2019 IRM Application EB-2018-0063
Response to Staff Interrogatories #2
January 31, 2019

1. Staff 25:

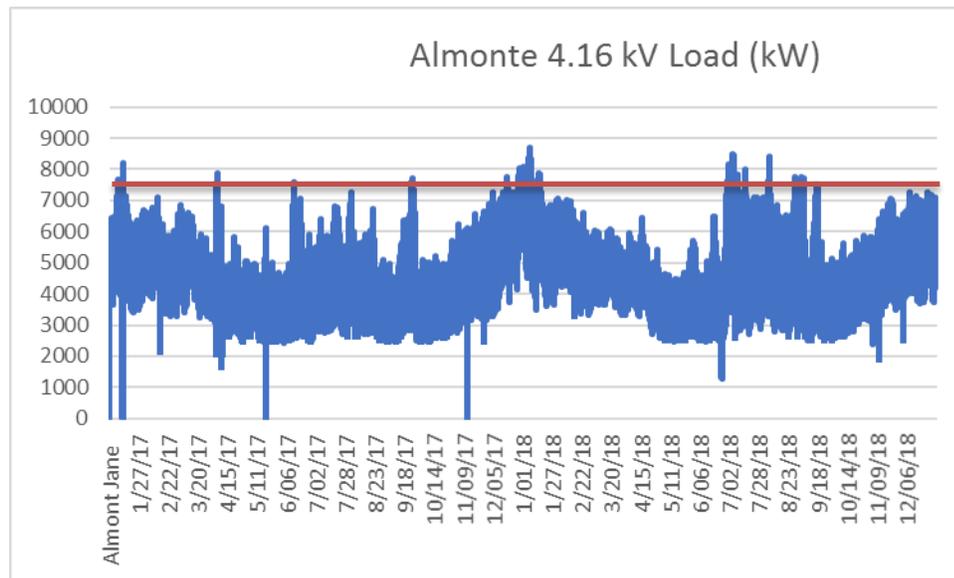
- a. Please discuss how the annual peaks are forecasted from 2019 and onwards. Please show calculations and assumptions.

Annual peaks are forecasted based upon historical trends and assumed load growth of 3%. The 3% growth rate is based upon the best available information from local authorities and developers.

One of the challenges with historical data is that the aggregated meter data for periods prior to 2017 is not available. We have attempted to confirm the assumed growth rate by looking at historical peak station loads, however, it is difficult to verify.

Figure 1 – MS-1 Transformer Nameplate

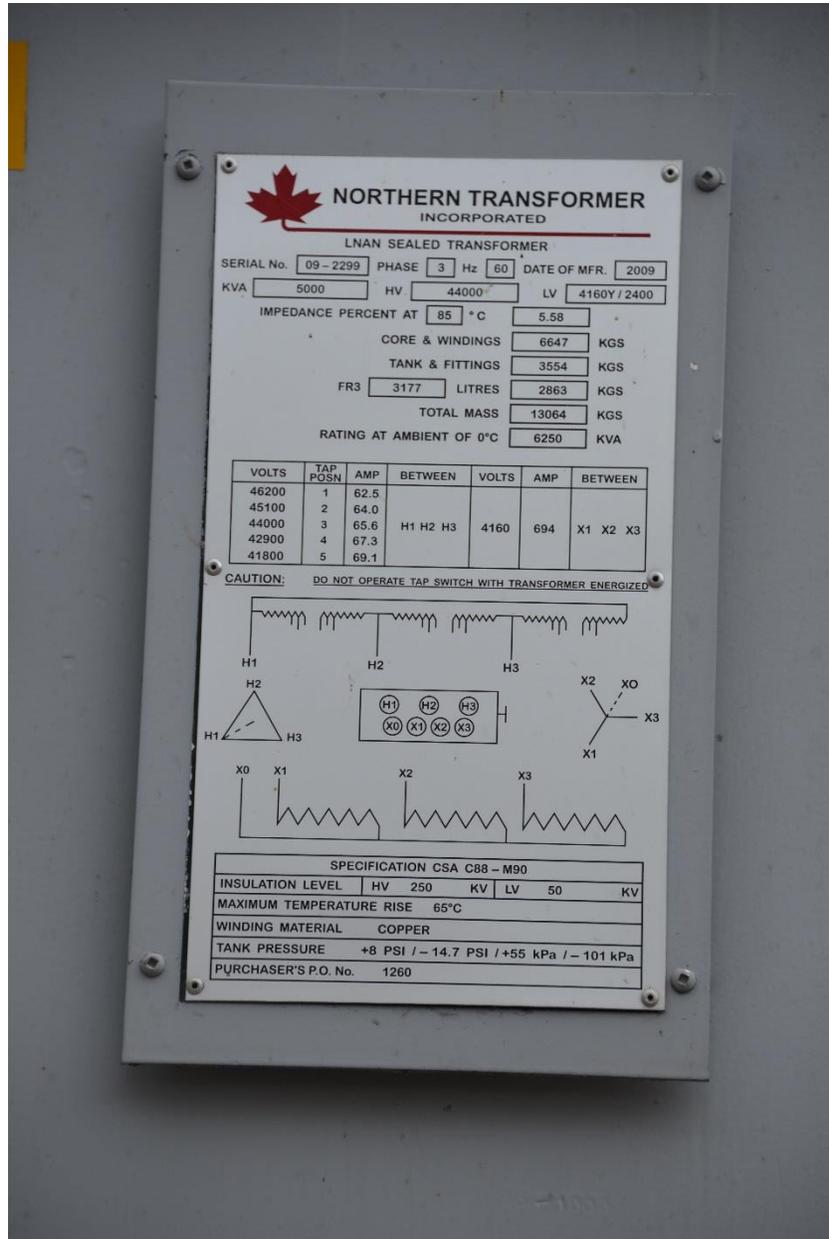
- a. Please explain why the nameplate image on drawing DSC_2412 contradicts the assertion that Almonte MS-1 has a 5 MVA rating.

- b. If the nameplate rating does not depict accurately the transformer capacity of MS-1, please clarify what the nameplate image in drawing DSC_2412 was intended to illustrate. If the evidence is not updated, please provide an image of the MS-1 transformer nameplate.

The Almonte MS-1 site has both the MS-1 5,000 kVA distribution station, and a generating station that also has a 5,000 kVA transformer connected to the 44 kV sub-transmission system. The generating station and its 5,000 kVA transformer are completely independent of the 4.16 kV station capacity discussion for Almonte. Both transformers were shown on a drawing that pre-dated the separation of the generation and distribution assets at the opening of the electricity market in 2002.
